**CONSENT ORDER BETWEEN PLAINTIFF UNITED STATES AND THE VIEWS AT
PINE VALLEY I, LP**

CEDAR VIEWS APARTMENTS – RETROFIT PLAN

PLANNED RETROFITS¹

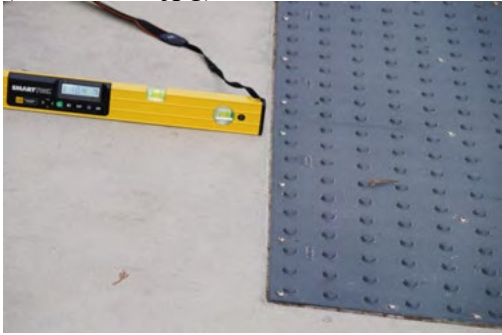
Inaccessible Feature	Photograph(s)	Retrofit(s)
A.4.	<p>To the right (north) of the curb ramp at the accessible parking north of the East Entrance, extending for about 10 feet, the cross slope is 6.6% to 7.1% (see line 27 of the Accessibility Report).</p> <p>Accessible route cannot have a cross slope that is more than 2%.</p> <p>(FHA Guidelines, Req. 1 or 2, 4.3.7; ADA 206.2.1; 403.3)</p>	 <p>(DSC01662.jpg)</p>  <p>(DSC01663.jpg)</p>  <p>(DSC01665.jpg)</p>	Remove and replace sidewalk.

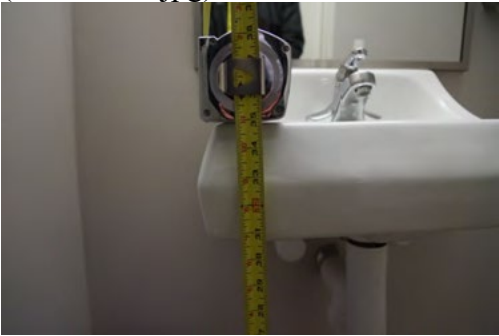
Inaccessible Feature	Photograph(s)	Retrofit(s)
			<ul style="list-style-type: none"> Proposed text and locations for all new signage related to the exterior accessible routes and to the interior route from the East Entrance to the main lobby are to be submitted to DOJ for review and approval prior to fabrication and installation. Submission to include proposed text, exact locations, materials and designs. <p>(See Accessible Route Diagram above.)</p>
B. Interior Common Areas			
First Floor Lobby			
B.1.	<p>The service counter on the office door is approximately 44" above the floor.</p> <p>The service counter is less than 36" wide and therefore must be no higher than 36".</p> <p>(ADA Standards 7.2(2), FHA Guidelines Req. 2, ANSI A117.1-1998 904.3)</p>	 <p>(DSC01467.jpg)</p>	<p>Remove the door and replace it with a door with a counter that is not higher than 36".</p>

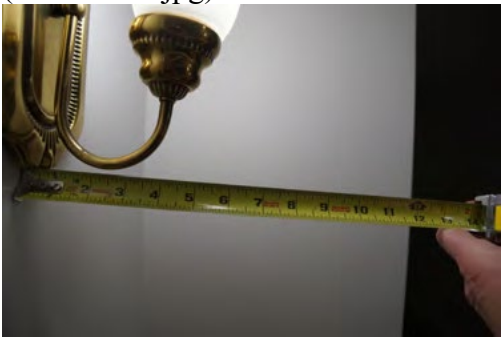
Inaccessible Feature	Photograph(s)	Retrofit(s)
B.7.	<p>The top of the wall-hung lavatory in the first floor restroom is 35" above the floor.</p> <p>Top of the lavatory and counter cannot be higher than 34".</p> <p>(ADA Standards 4.1.3(11), 4.19.2, FHA Guidelines Req. 2, 4.19.2.2)</p>	 <p>(DSC01441.jpg)</p>  <p>(DSC01442.jpg)</p>	<p>Lower lavatory so that the top is no higher than 34".</p>

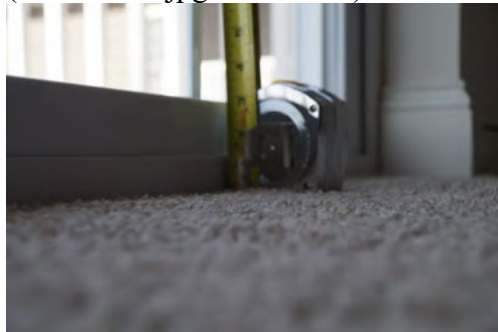
Inaccessible Feature	Photograph(s)	Retrofit(s)
B.9.	<p>The front end of the sidewall grab bar in the first floor restroom is 47" from the rear wall.</p> <p>The grab bar must be at least 42" long, must be within 12" of the rear wall, and must extend at least 54" from the rear wall.</p> <p>(ADA Standards 4.1.3(11), 4.16.4, FHA Guidelines Req. 2, 4.16.4)</p>	 <p>(DSC01450.jpg)</p>	<p>Relocate grab bar so that the front end of the grab bar is within 12" of the rear wall and the far end extends at least 54" from the rear wall.</p>
B.10.	<p>The far side of the toilet paper dispenser in the first floor restroom is 48 1/2" from the rear wall. The centerline of the dispenser is 15" in front of the toilet.</p> <p>When provided, the entire toilet paper dispenser must be no more than 36" from the rear wall. The 2010 ADA Standards permit the centerline of the toilet paper dispenser to be 7" to 9" in front of the toilet.</p> <p>(ADA Standards 4.1.3(11), 4.16.6, FHA Guidelines Req. 2, 4.16.6)</p>	 <p>(DSC01453.jpg)</p>	<p>Relocate toilet paper dispenser so that it is within 36" of the rear wall, with its centerline within 7" to 9" in front of the toilet.</p>

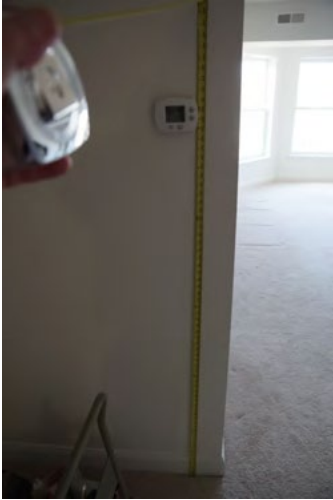
Inaccessible Feature	Photograph(s)	Retrofit(s)
B.13.	<p>In the trash rooms, the control on the trash chute intake door requires 10 to 11 pounds force.</p> <p>The control for the trash chute intake door must be openable with no more than 5 pounds force.</p> <p>(FHA Guidelines Req. 2, 4.25.4)</p>	 <p>(DSC00958.jpg)</p> <p>(DSC00959.jpg)</p>	<p>If feasible, adjust the chute intake doors to reduce the amount of force required for operation.</p>

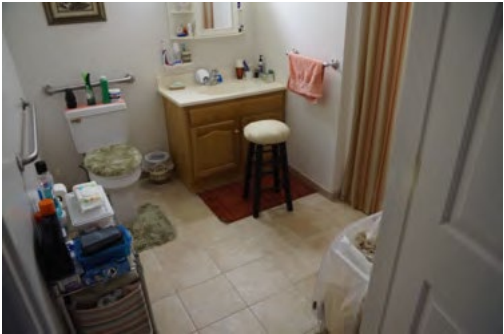
Inaccessible Feature	Photograph(s)	Retrofit(s)
D. Dwelling Units – Unit Type Specific Retrofits		
Type A – 2 Bedroom, 2 Bath (28 Units of this Type) (Surveyed Units: 325 and 328)		
<p>D.1. The smaller bedroom walk-in closet is 47” deep and the clear opening is 27 1/2”.</p> <p>If the closet is deeper than 24”, the closet door is intended for user passage. It must provide at least 31 5/8” clear opening.</p> <p>(FHA Guidelines Req. 3(2))</p>	 <p>(DSC00874.jpg – Unit 325)</p> <p>(DSC00872.jpg – Unit 325)</p>	<p>If feasible (i.e., where the closet is at least 36” wide) remove door and install cased opening to provide at least 31 5/8” clear opening.</p> <p>If not feasible, post laminated notice in the closet notifying the resident that closet fittings (shelves and hanging rod/bar) can be relocated or depth of closet reduced to 24” on request of the resident. Submit wording for notice to DOJ for review prior to printing notice.</p>

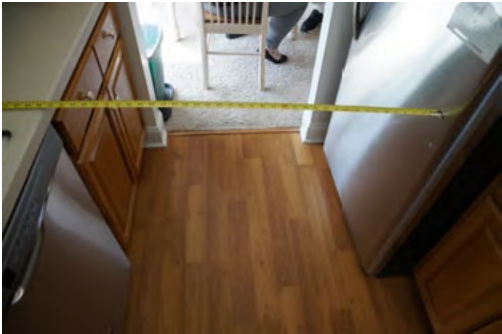
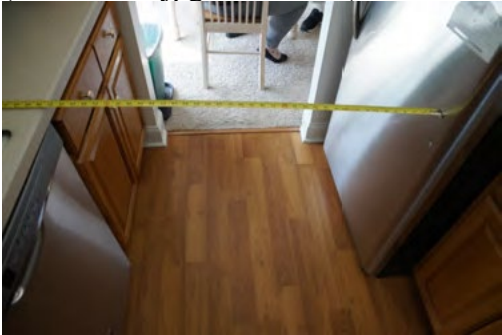
Inaccessible Feature	Photograph(s)	Retrofit(s)
Type B – 1 Bedroom, 1 Bath (2 Units of this Type) (Surveyed Units: 419 and 421)			
D.3.	<p>The coat closet is more than 24” deep and the clear opening is 21 1/2”.</p> <p>If the closet is deeper than 24”, the closet door is intended for user passage. It must provide at least 31 5/8” clear opening.</p> <p>(FHA Guidelines Req. 3(2))</p>	No photos taken.	<p>If feasible (i.e., where the closet is at least 36” wide) remove door and install cased opening to provide at least 31 5/8” clear opening.</p> <p>If not feasible, post laminated notice in the closet notifying the resident that closet fittings (shelves and hanging rod/bar) can be relocated or depth of closet reduced to 24” on request of the resident. Submit wording for notice to DOJ for review prior to printing notice.</p>

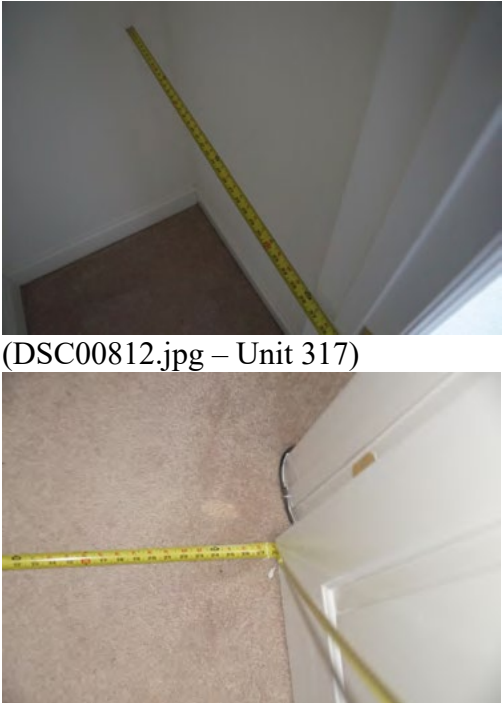
Inaccessible Feature	Photograph(s)	Retrofit(s)
<p>D.7. The parallel clear floor space for the lavatory is off-center by 5 1/2". A forward approach is blocked by a vanity.</p> <p>Clear floor space for the lavatory must be at least 30" by 48". It must be centered. If forward, knee and toe space must be provided under the lavatory.</p> <p>(FHA Guidelines Req. 7(2)(a)(ii) or 7(2)(b)(v))</p>	 <p>(DSC01267.jpg – Unit 421)</p>  <p>(DSC01270.jpg – Unit 421)</p>	<p>Relocate lavatory or replace vanity with unit that has a removable cabinet.</p>

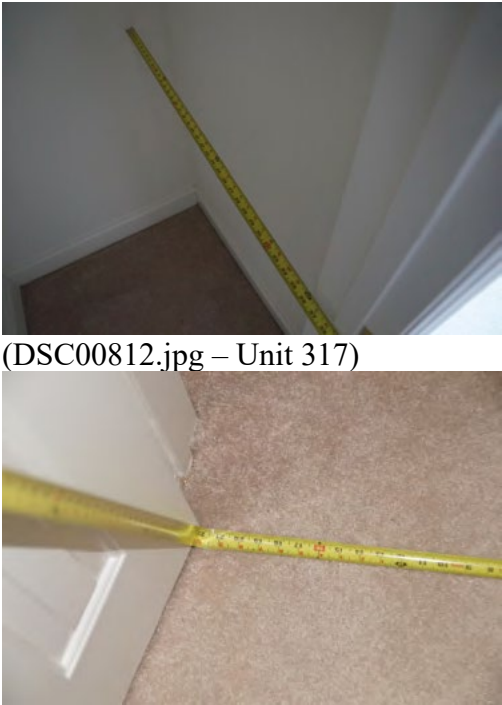
Inaccessible Feature	Photograph(s)	Retrofit(s)
Type B – 2 Bedroom, 1.5 Bath (8 Units of this Type) (Surveyed Units: 214 and 230)		
<p>D.8. The smaller bedroom walk-in closet is 36" deep and the clear opening is 27 1/2".</p> <p>If the closet is deeper than 24", the closet door is intended for user passage. It must provide at least 31 5/8" clear opening.</p> <p>(FHA Guidelines Req. 3(2))</p>	 <p>(DSC01348.jpg – Unit 214)</p>  <p>(DSC01185.jpg – Unit 230)</p>	<p>If feasible (i.e., where the closet is at least 36" wide) remove door and install cased opening to provide at least 31 5/8" clear opening.</p> <p>If not feasible, post laminated notice in the closet notifying the resident that closet fittings (shelves and hanging rod/bar) can be relocated or depth of closet reduced to 24" on request of the resident. Submit wording for notice to DOJ for review prior to printing notice.</p>

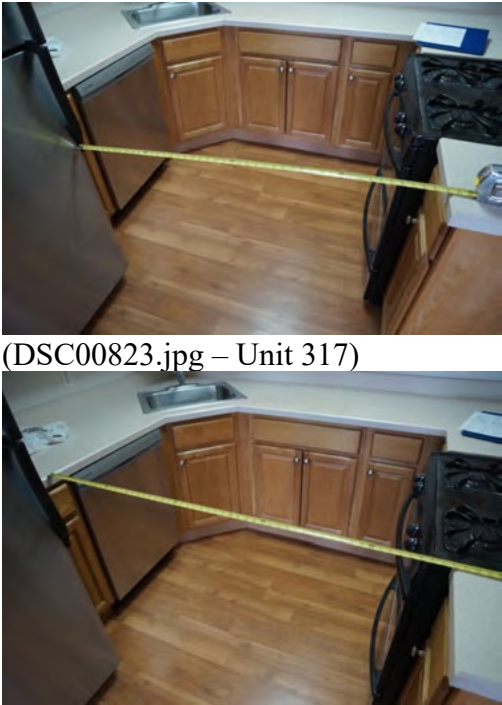
Inaccessible Feature	Photograph(s)	Retrofit(s)
D.9.	<p>At the powder room door, the top of the threshold is 1/2". It is not beveled.</p> <p>The dwelling unit entrance is in an interior corridor. The threshold cannot be taller than 1/2". Where the top of the threshold is more than 1/4" above the landing, the transition must be beveled at least 1:2.</p> <p>(FHA Guidelines Req. 4(4))</p> <p>(Note: This issue was observed in Unit 214 but not in Unit 230.)</p>	 <p>(DSC01342.jpg – Unit 214)</p>	<p>Modify or replace threshold so that it is no taller than 1/2" and, if necessary, beveled at least 1:2 with a vertical edge that is no taller than 1/4".</p>

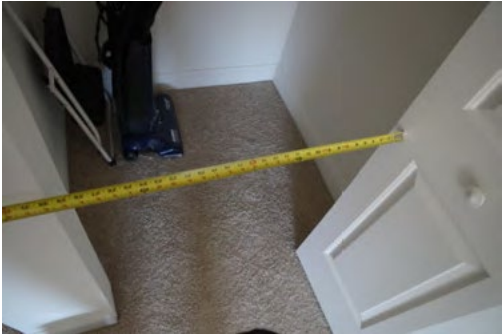
Inaccessible Feature	Photograph(s)	Retrofit(s)
D.11.	<p>In the master bathroom, the toilet centerline is 14 1/2" from the sidewall.</p> <p>Toilet centerline must be at least 18" from the sidewall or bathtub.</p> <p>(FHA Guidelines Req. 7(2)(a)(ii) or 7(2)(b)(iv))</p> <p>(Note: This issue was observed in Unit 230 but not in Unit 214.)</p>	 <p>(DSC01192.jpg – Unit 230)</p>	<p>Retrofit toilets that have either of the following inaccessible features on the far side of the fixture:</p> <ul style="list-style-type: none"> a. Toilet centerlines that are less than 17" from an adjacent tub, shower, or wall surface that is less than 28" in length; or b. Toilet centerlines that are less than 15 1/2" from an adjacent side wall that is minimum 28" long. <p>Relocate toilet to position required by the safe harbor.</p> <p>Exception 1: where a toilet is less than 15-1/2" from an adjacent tub, shower, or wall surface located on the far side of the toilet and there is no 28" sidewall, relocate the toilet as far as possible towards the direction of approach using an offset flange. Document centerline conditions before and after relocation. Provide list of toilets affected by this exception and their centerline dimensions before and after relocation to the DOJ and the neutral inspector prior to the inspection.</p>

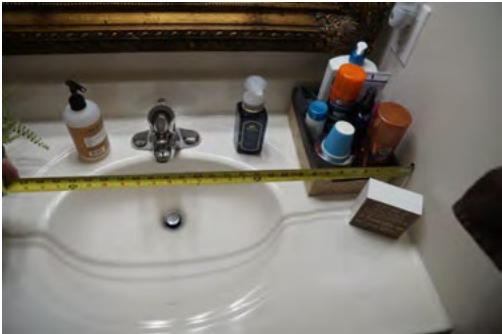
Inaccessible Feature	Photograph(s)	Retrofit(s)
Type E – 2 Bedroom, 2 Bath (8 Units of this Type) (Surveyed Units: 17 and 211)		
<p>D.19. The coat closet in Unit 17 is 36” deep and the clear opening is 15 1/2”. The coat closet in Unit 211 is 26” deep and the clear opening is 15 1/2”.</p> <p>If the closet is deeper than 24”, the closet door is intended for user passage. It must provide at least 31 5/8” clear opening.</p> <p>(FHA Guidelines Req. 3(2))</p>	 <p>(DSC01044.jpg – Unit 17)</p>  <p>(DSC01045.jpg – Unit 17)</p>	<p>If feasible (i.e., where the closet is at least 36” wide) remove door and install cased opening to provide at least 31 5/8” clear opening.</p> <p>If not feasible, post laminated notice in the closet notifying the resident that closet fittings (shelves and hanging rod/bar) can be relocated or depth of closet reduced to 24” on request of the resident. Submit wording for notice to DOJ for review prior to printing notice.</p>

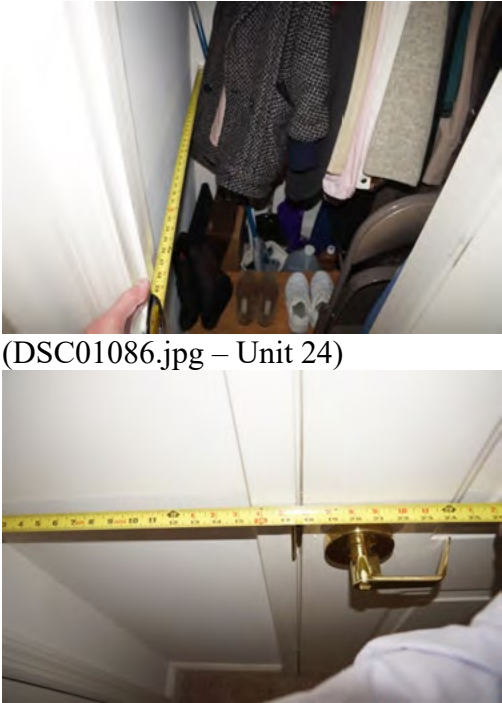
Inaccessible Feature	Photograph(s)	Retrofit(s)
			<p>Exception 2: notify DOJ prior to retrofitting toilet if there are unforeseen conditions affecting the relocation of the fixture. For example, if relocation of the toilet reduces near side clear space to less than 14”, retrofit clearances may need to be adjusted.</p>

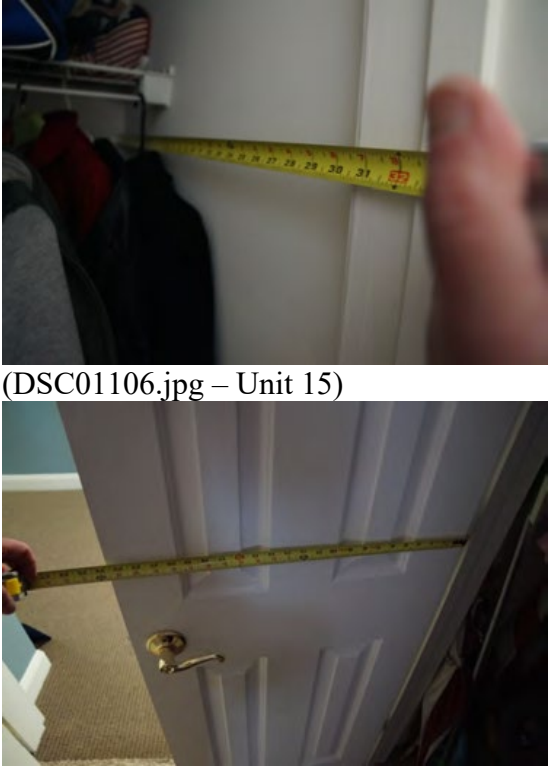
Inaccessible Feature	Photograph(s)	Retrofit(s)
Type J – 2 Bedroom, 1.5 Bath (2 Units of this Type) (Surveyed Units: 16 and 18)		
<p>D.35. The smaller bedroom walk-in closet is about 42” deep and the clear opening is 27 1/2”.</p> <p>If the closet is deeper than 24”, the closet door is intended for user passage. It must provide at least 31 5/8” clear opening.</p> <p>(FHA Guidelines Req. 3(2))</p>	 <p>(DSC01421.jpg – Unit 16)</p> <p>(DSC01420.jpg – Unit 16)</p>	<p>If feasible (i.e., where the closet is at least 36” wide) remove door and install cased opening to provide at least 31 5/8” clear opening.</p> <p>If not feasible, post laminated notice in the closet notifying the resident that closet fittings (shelves and hanging rod/bar) can be relocated or depth of closet reduced to 24” on request of the resident. Submit wording for notice to DOJ for review prior to printing notice.</p>
